Access Compliance Report

Public Rights-of-Way

(Curb Ramps)

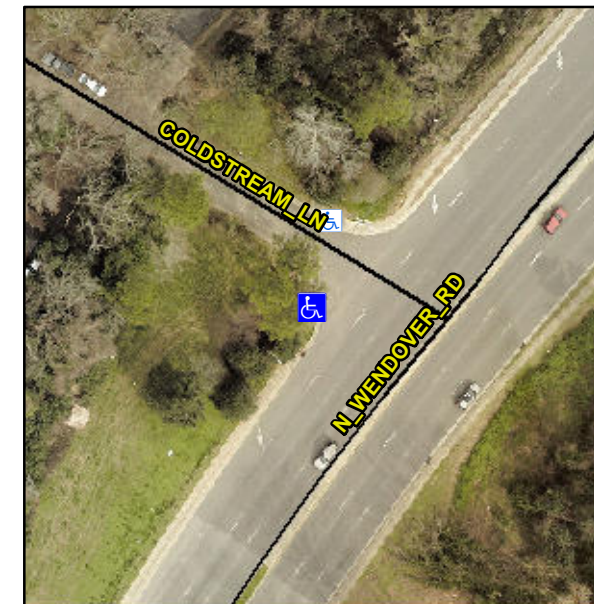
Intersection ID: 15514	Main Street: COLDSTREAM_LN	Cross Street: N WENDOVER RD	Location: NW
ADA ID: 83EE8042A6A6	Ramp Type: Perp	Initial Pass/Fail: Fail	Overall Compliance: No
Severity Score: 46.25			
Codes/Mitigation Info/Possible Solution		Field Measurements/Component Compliance

Not Found, R304.5.1, R304.2.2, R304.5.3

Compliance	Description	Data	Compliance	Description	Data
N/A	Ramp Length (in)	65.0	No	Ramp Slope (%)	11.3
No	Ramp Width (in)	45.0	No	Ramp XSlope (%)	7.4
N/A	Flare Type LT	N/A	N/A	Flare Type RT	N/A
N/A	Flare Slope LT (%)	N/A	N/A	Flare Slope RT (%)	N/A
N/A	Flare Traversable LT?	N/A	N/A	Flare Traversable RT?	N/A
N/A	Landing Length (in)	N/A	N/A	DWS Provided?	N/A
N/A	Landing Width (in)	N/A	N/A	DWS Contrast?	N/A
N/A	Landing Slope (%)	N/A	N/A	DWS Length (in)	N/A
N/A	Landing X Slope (%)	N/A	N/A	DWS Full Width?	N/A
N/A	Landing Curb? (Y/N)	N/A	N/A	DWS Offset (in)	N/A
N/A	Shared Landing?	N/A			
N/A	Gutter Ponding?	N/A	N/A	Gutter Slope (%)	N/A
N/A	Gutter Lip Ht (in)	N/A	N/A	Gutter X Slope (%)	N/A
N/A	Painted X Walk1?	No	N/A	Painted X Walk2?	N/A
	X Walk 1 Direction	To NE		X Walk 2 Direction	N/A
N/A	X Walk 1 Width (in)	N/A	N/A	X Walk 2 Width (in)	N/A
	X Walk 1 Slope (%)	0.3		X Walk 2 Slope (%)	N/A
	X Walk 1 X Slope (%)	3.7		X Walk 2 X Slope (%)	N/A

Remove & Replace Entire Ramp.
